# 1968 Corvette: Service Bulletin: General Information

**Bulletin No:** 68-T-43

**Date:** April 24, 1968

Subject: 1968 CORVETTE  
GENERAL INFORMATION

#### Astro Ventilation - Poor Air Flow

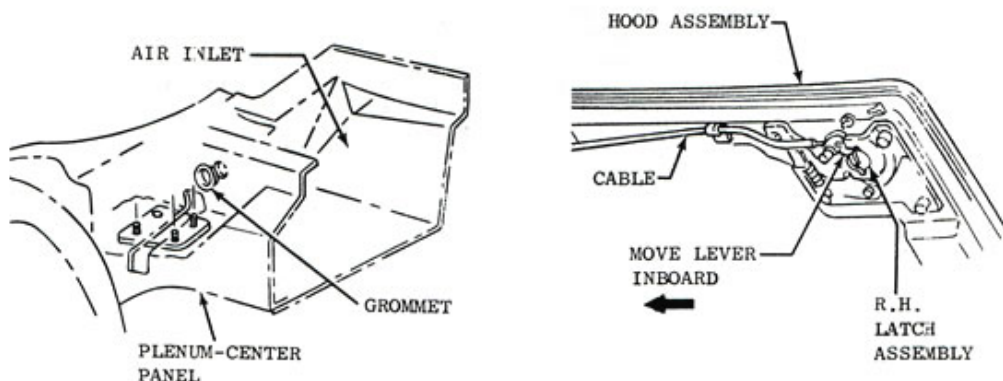
The amount of air flow through the Astro Ventilation System may be restricted if the flapper type valves are improperly cemented to the valve frame. These valves are located under the rear deck and should swing freely as pressure builds up in the passenger compartment.

In instances where the valve action is restricted, separate the rubber flaps from the frame along the bottom and sides. The Astro Vent ducting and cowl kick pad vents should also be checked for leakage as this will reduce air flow at the nozzles.

#### Rear Bow Lock Remote Control Cable Rattle

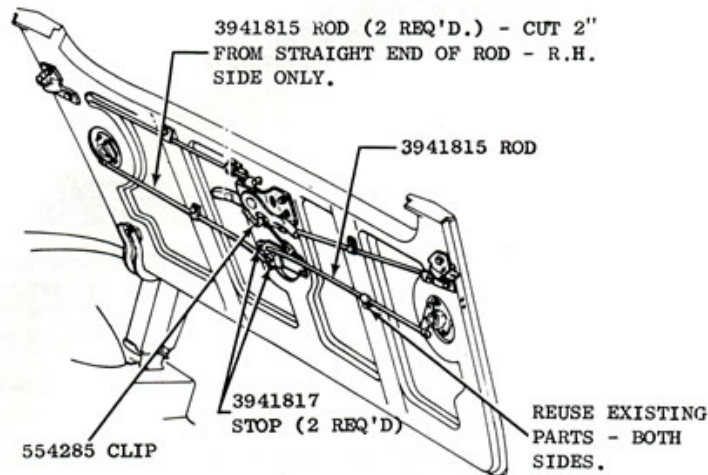
Remote control cables used on early 1968 Corvette Convertible models could rattle against the rear compartment lid. Production replaced these cables with rods on 1/2/68.

Complaint vehicles may be updated by installing the rear bow lock remote control rods as indicated on the sketch below.

Headlamp Door - Inoperative

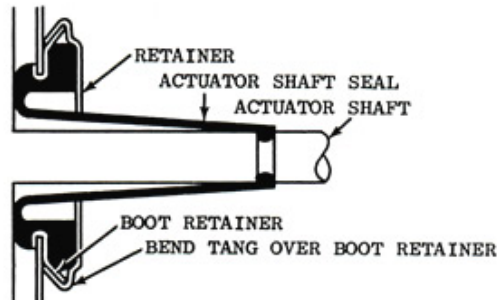
Headlamp doors which become inoperative due to sticking actuator shaft seals, should be corrected by replacing the inner shaft seal. This seal, in some cases, will stick to the actuator shaft causing the seal to pull out of the actuator. The headlamps may be operated manually as outlined in the 1968 Corvette Owners Manual when this occurs. The new style actuator seals went into production effective with Serial No. S410514. The actuator seals may be replaced as follows:

- b) Make certain seal grommet is properly seated in the actuator cover and interior bead at small diameter of seal fits in the groove on the shaft (See sketch)

- c) Apply a liberal film of silicone lubricant over entire exterior surface of actuator shaft seal, excluding grommet
  5. Install the retainer by bending the three (3) tabs over edge of boot retainer. (See sketch)
